RWC-1021

2023 Inspection

Retaining Wall Inventory Data

Retaining Wall Inspection Report

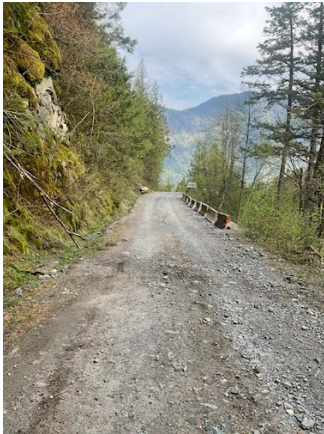
From town approach
